THIRD FLOOR PLAN
SCALE 1:100 @ A0

RESIDENTIAL FLAT
 BUILDING- 1147, 1149
 PACIFIC HWY & 2 BOBBIN
 HEAD ROAD PYMBLE
 DRAWING NO. 1147-1149
THIRD FLOOR PLAN

Scale: 1:100 @ A0 22/07/2011
 Drawing no. JA
 Check: DM
SK08B

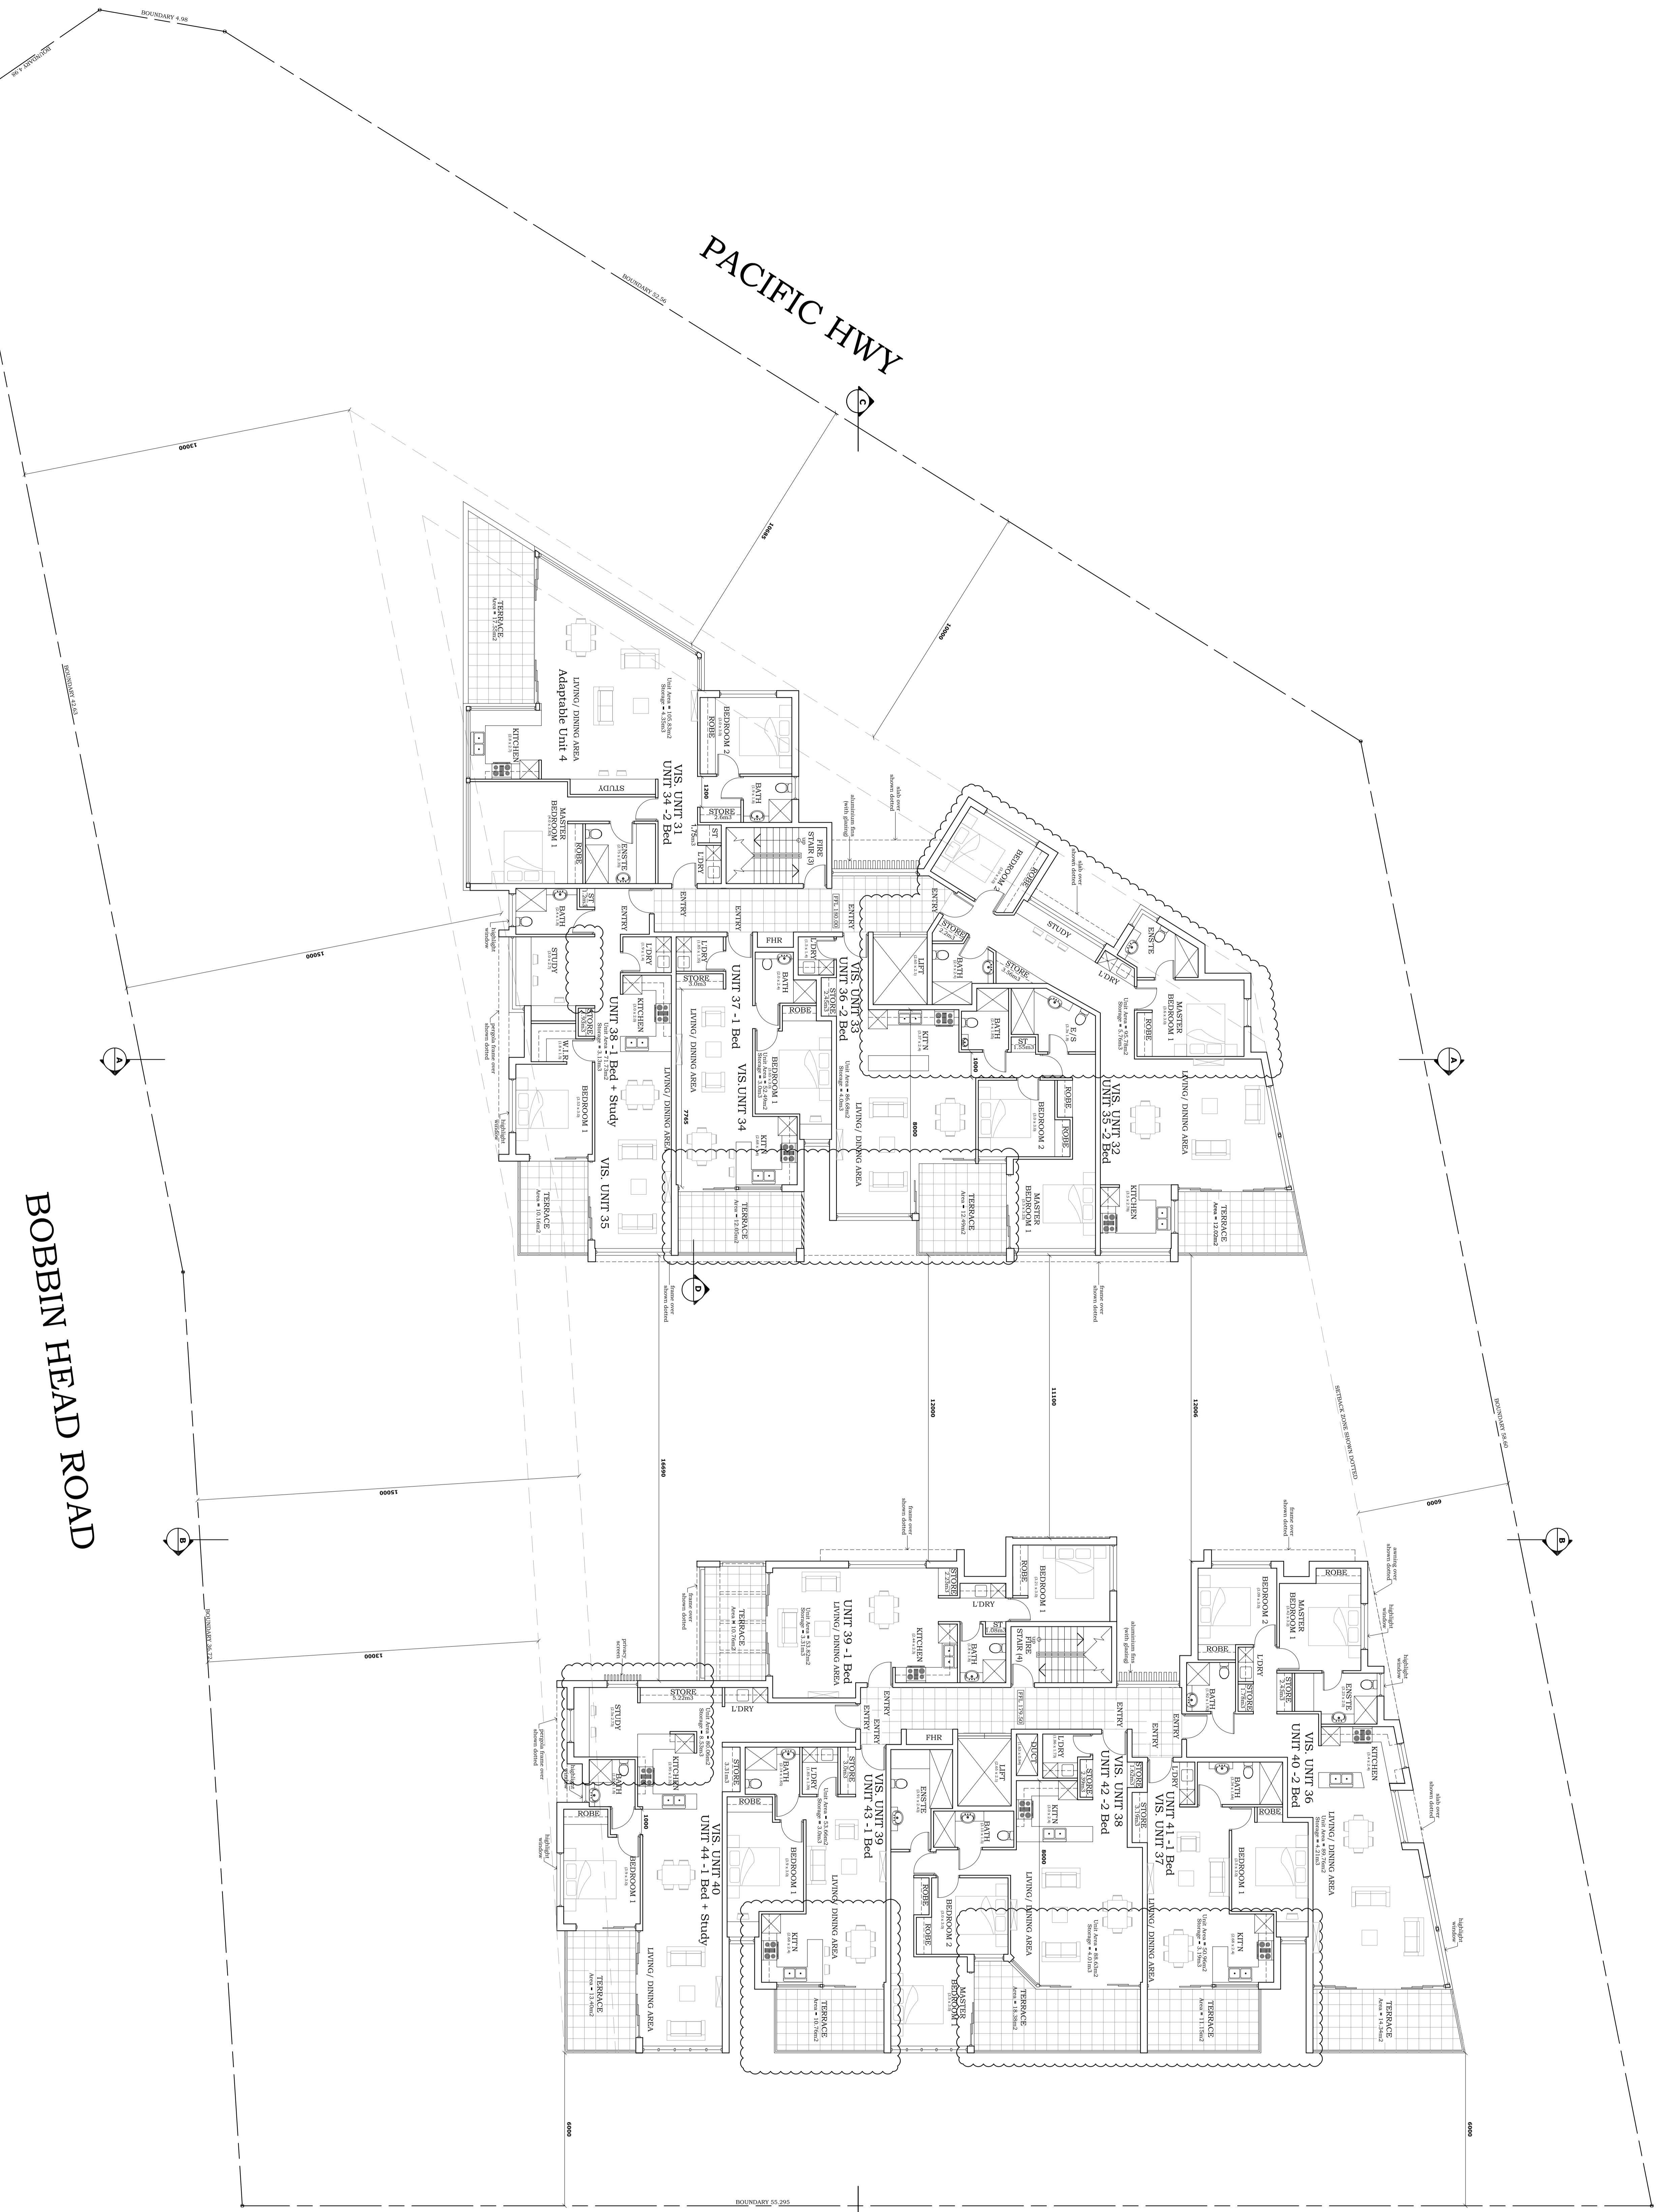
REV	AMENDMENTS	DATE
B	- Lift in southern block has been relocated - Units 35, 36, 37, 41, 42 & 43 have been reconfigured so that the kitchen are no more than 8m to a window - Wall has been removed from study of units 38 & 44 - Window and privacy unit 44 added to study of unit 44	06.12.11
